OJAI UNIFIED SCHOOL DISTRICT

BID ADDENDUM NO. 5 **ISSUED 2/6/2019**

GYMNASIUM REROOF AND LOCKER ROOM REMODEL AT MATILIJA JUNIOR HIGH SCHOOL PROJECT NO. 2018-1602

ADDENDUM NO. 6

② PLUMBING FLOOR PLAN
1/8" = 1'-0"

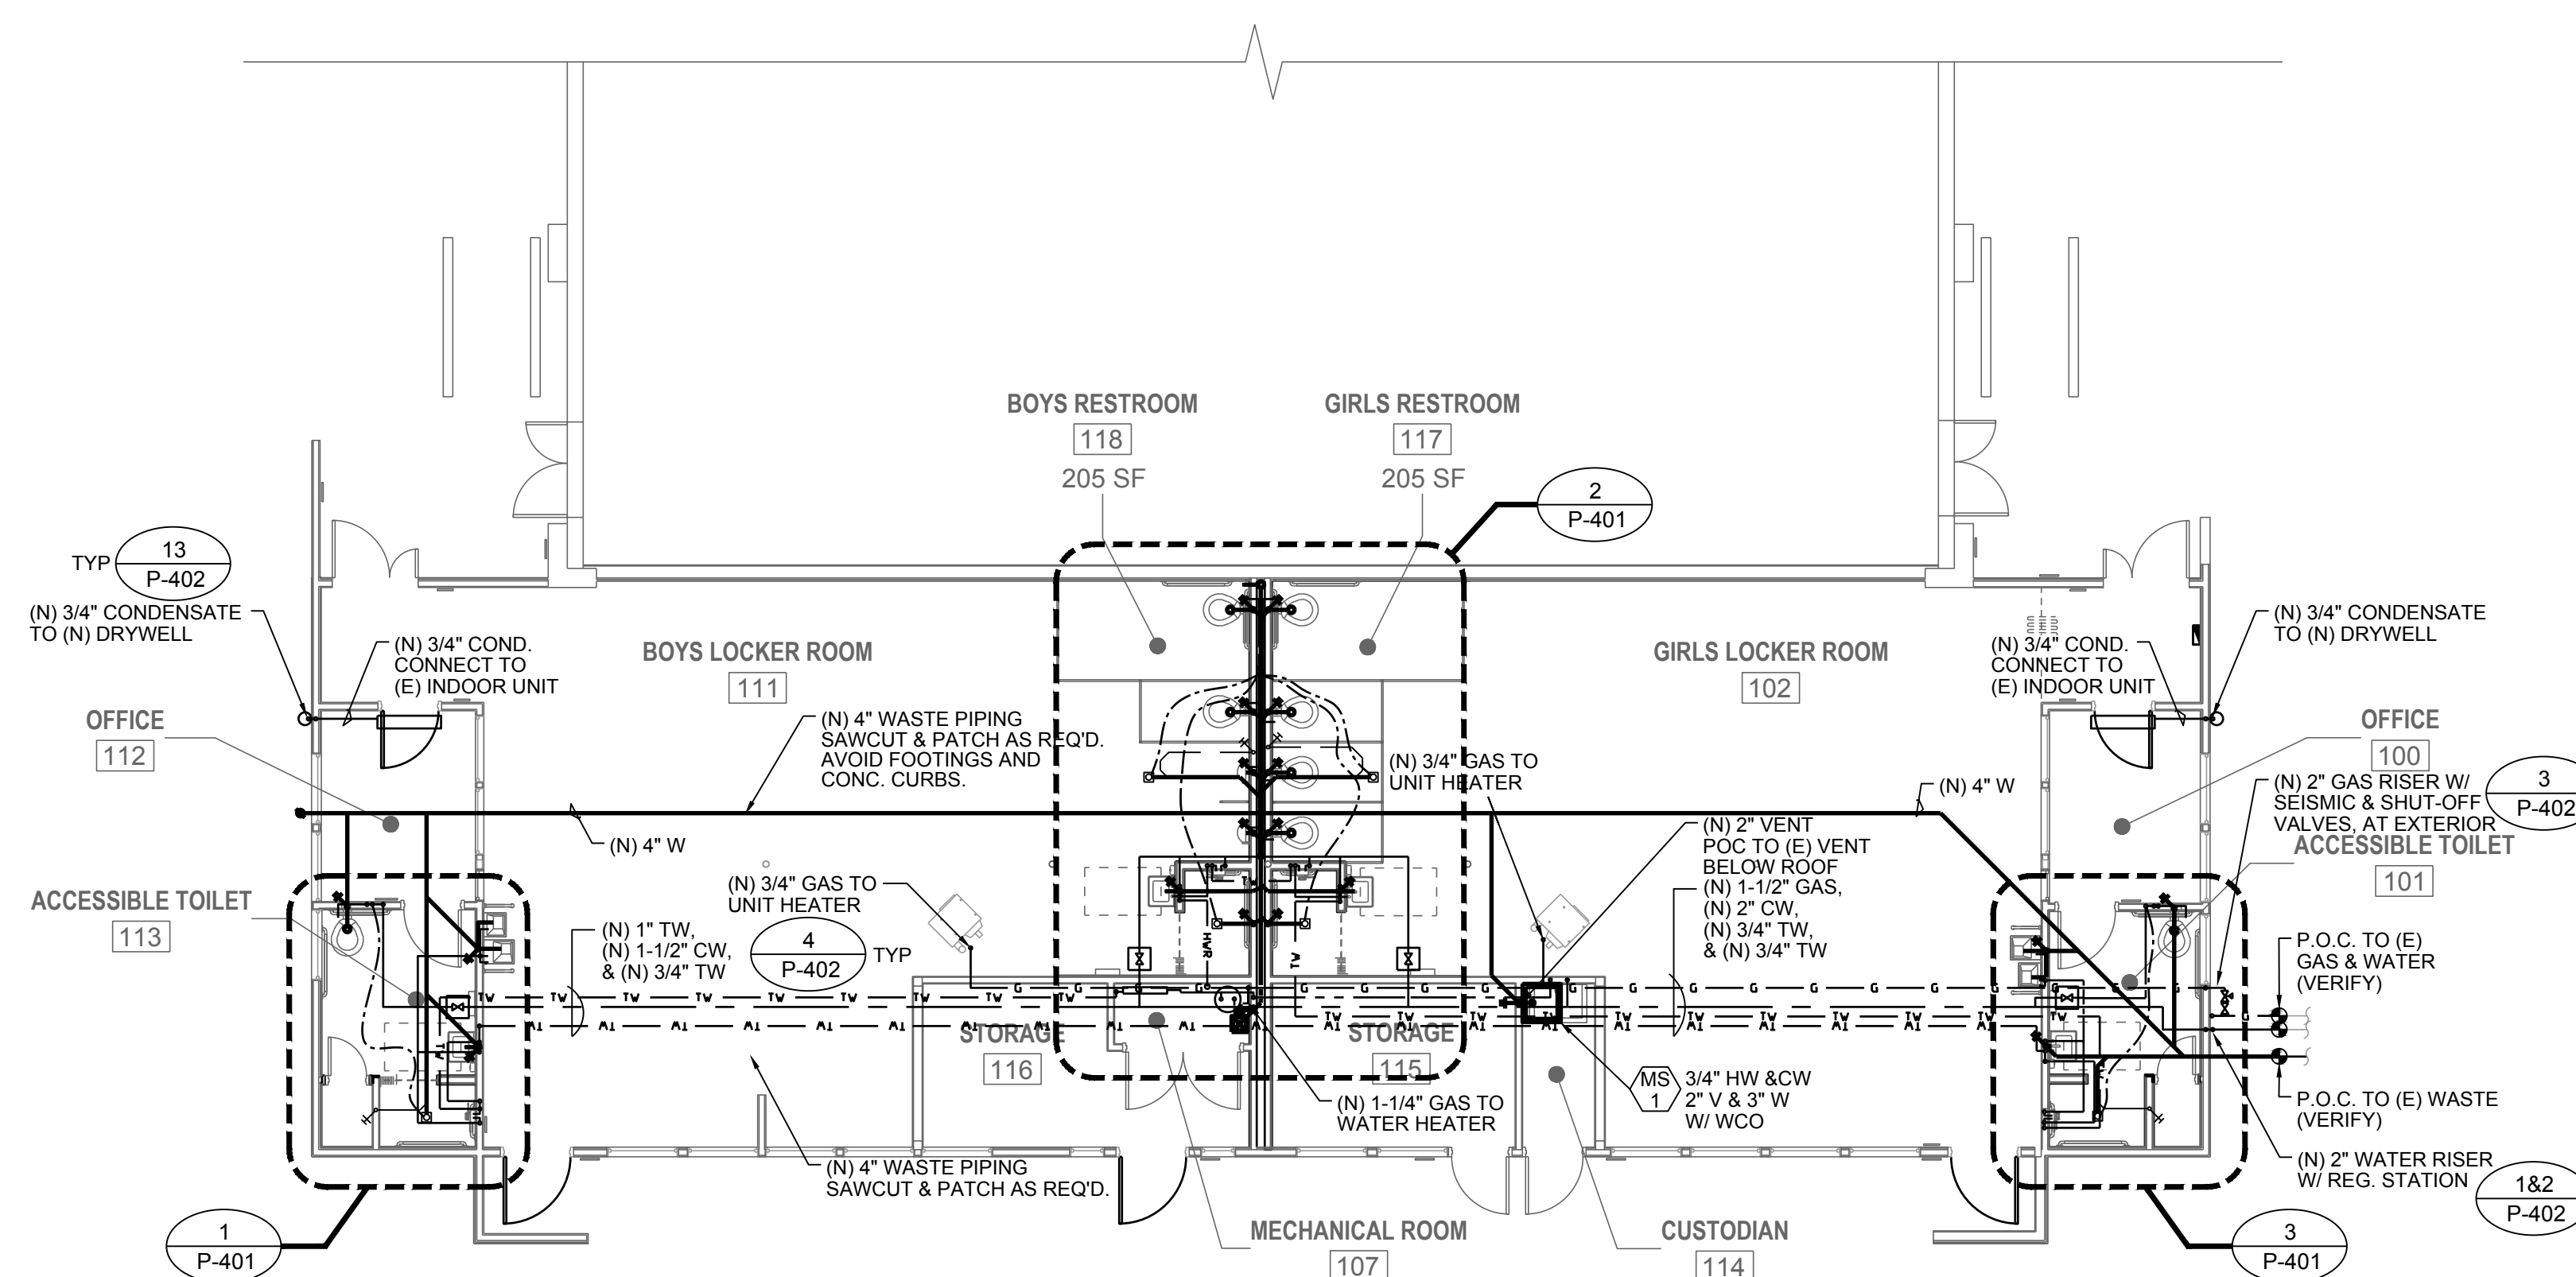
No.	QUESTION	RESPONSE	RESPONSE BY
1	Structural plan S-201 shows a new 14'-6" long x 4'-6" wide x 3'-6" deep footing being installed under new shear walls at (2) locations. Plumbing plan P-201 shows the new 4" waste line running directly through both footings. I assume the existing waste is not deep enough to allow us to run below the new footing. a. Is the intent that we run the	Revised plumbing drawing P-201 shows plumbing routed around footing and mop sink relocated to avoid conflicts.	RNT Architects

new waste directly through the footings? If so please provide detail.

b. Will we be required to run around these footings? If so, what is the preferred routing path? paint/epoxy as well.

Item 1 **Sheet P-201 Plumbing Floor Plan** revised to show waste line routed around structural footings and the mop sink relocated to avoid footing.
